APPENDIX II-J

APPLICABILITY OF SSAP CORES FOR ESTIMATION OF PCB MASS IN UNEXPECTED INVENTORY: THE THOMPSON ISLAND DAM 2009

March 5, 2010

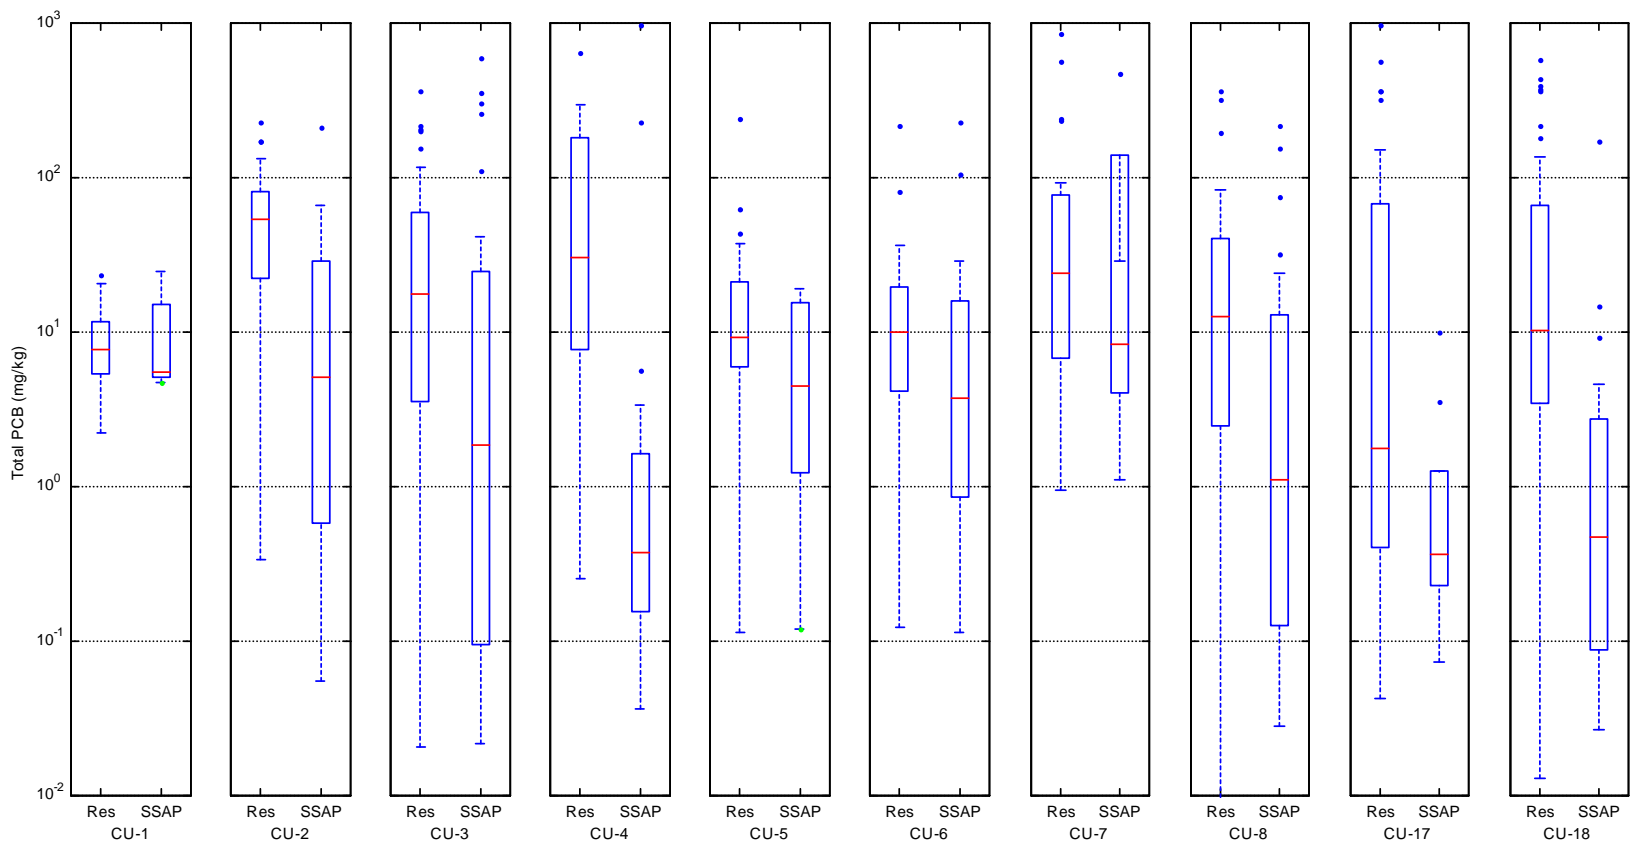
These subsets of data were grouped by CU and summarized as boxplots in Figure 1. In all 10 CUs dredged in 2009 the median (horizontal red line) PCB concentration for SSAP cores is less than that for the corresponding post-dredging core distribution. Under the null hypothesis of equal

median concentrations the probability of observing fully 100 percent of the medians from the SSAP population below that of the post-dredging population is $0.5^{10} = 1/1000$. This strongly suggests that the SSAP data are not representative of PCB concentrations in the 6-inch layer of unexpected inventory directly below the design cut lines.

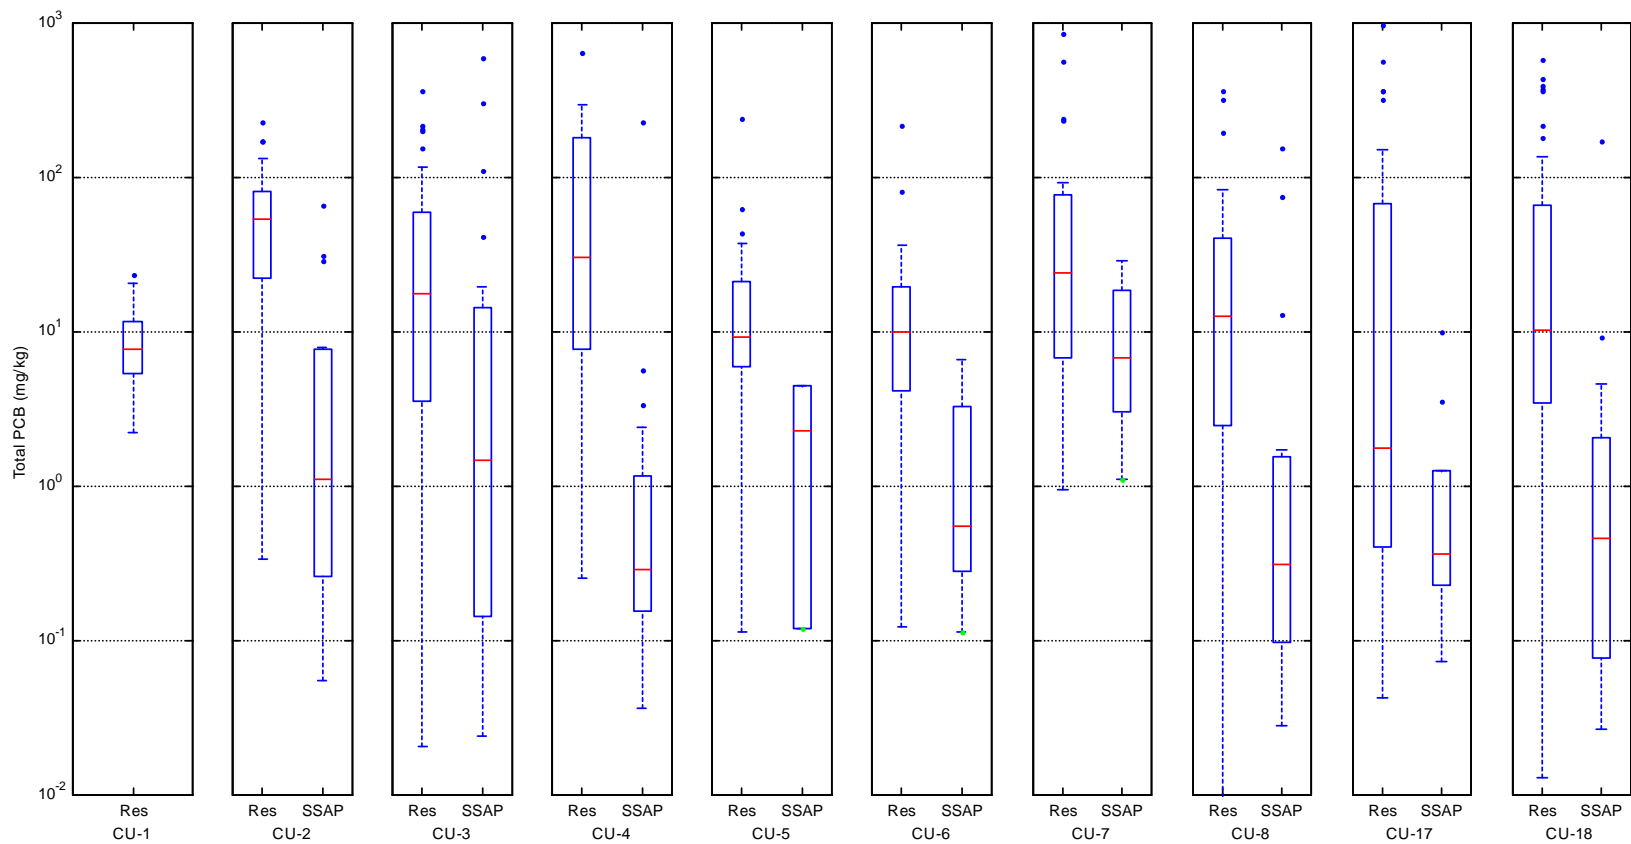
One might conjecture that this bias is primarily due to the incomplete subset of the cores in hopes that the complete SSAP cores (*i.e.*, high confidence cores) might be suitable for application to estimation of mass of PCBs removed. To investigate this question incomplete cores were removed from the data and the distributions were again compared (Figure 2). Removal of the incomplete cores actually increases the magnitude of the bias, so calculations that preferentially incorporate complete cores would be expected to accentuate the degree to which mass may be understated when the SSAP cores are incorporated into the analysis.

Figure 4. Relative percent difference between GE and EPA estimates as a function of dredge pass.

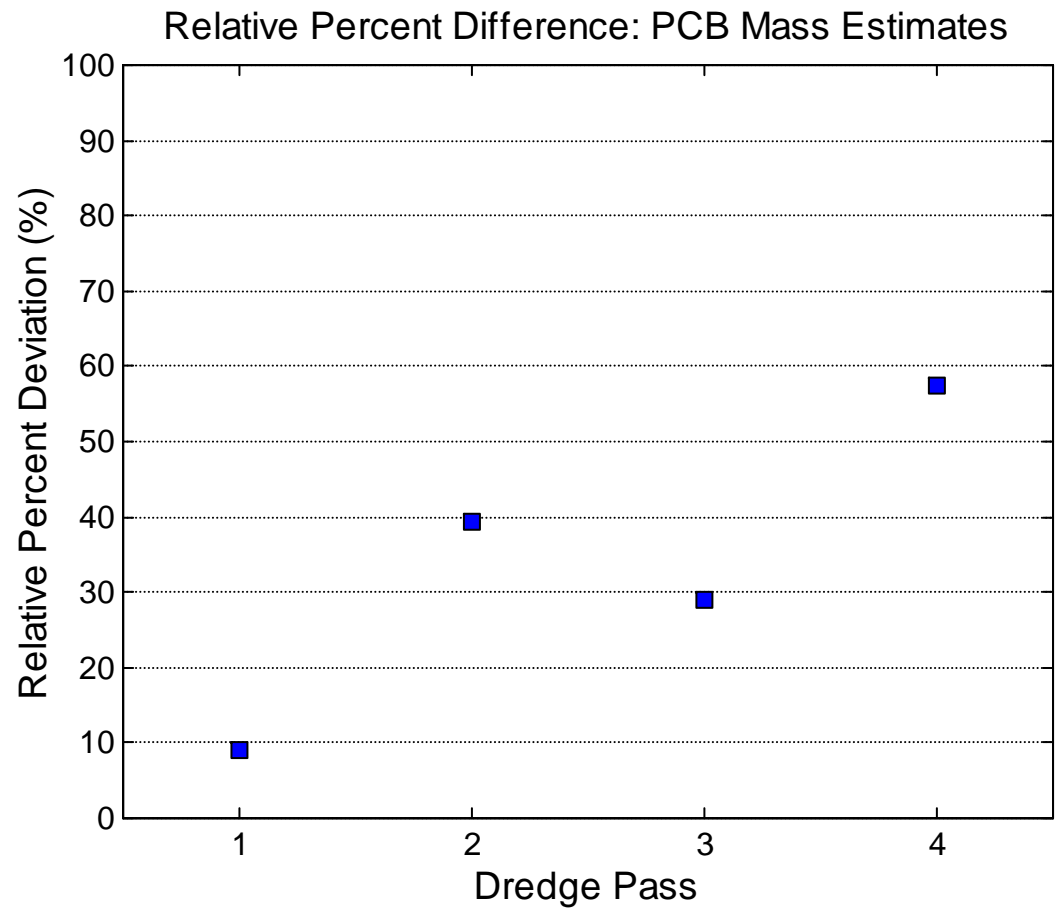
This can be investigated by comparing the RPD between EPA and GE estimates as they relate to successive dredging passes. Figure 4 shows that RPDs between EPA and GE mass estimates increase with each dredging pass, ranging from around 10 percent in the first dredge pass to nearly 60 percent by the fourth dredge pass. This may be due to the bias in the SSAP data described above.

GE argues that dredging beyond the first or perhaps second pass is inefficient based on these mass estimates, which unlike EPA's estimates, decline substantially on a per unit volume basis with increasing depth. This understatement of PCB mass is likely due to:
